### 3200 BHT Slide out room issues

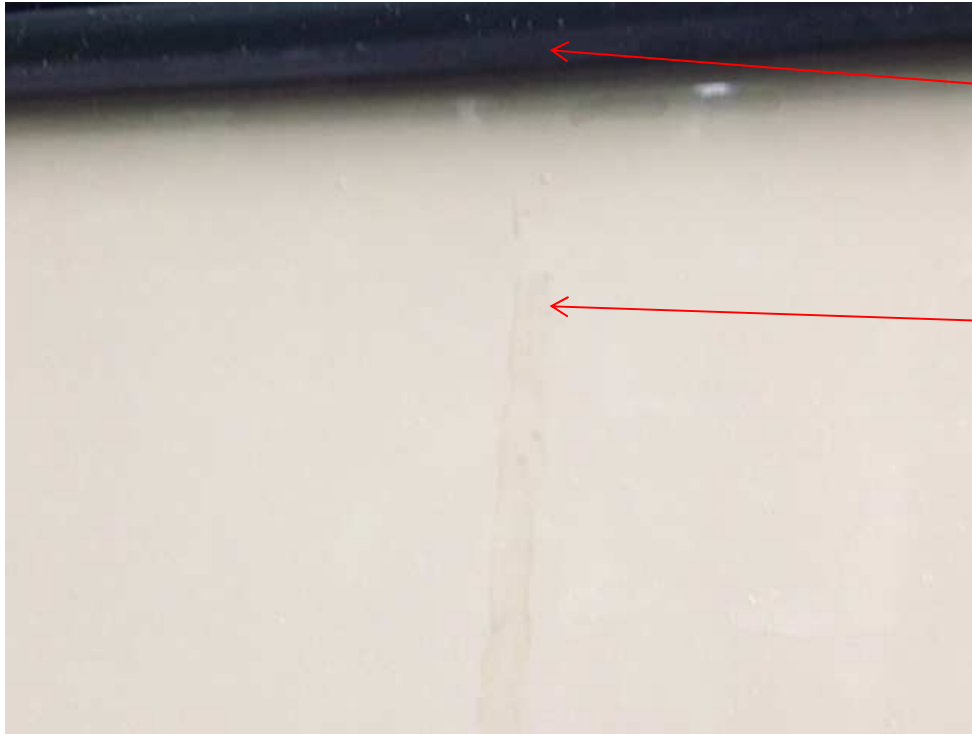
Black Trim overlapping wall.

Streak of water running down

End of sealant  
tape

Water collects and seeps  
Under.

No tape and exposed  
screws.
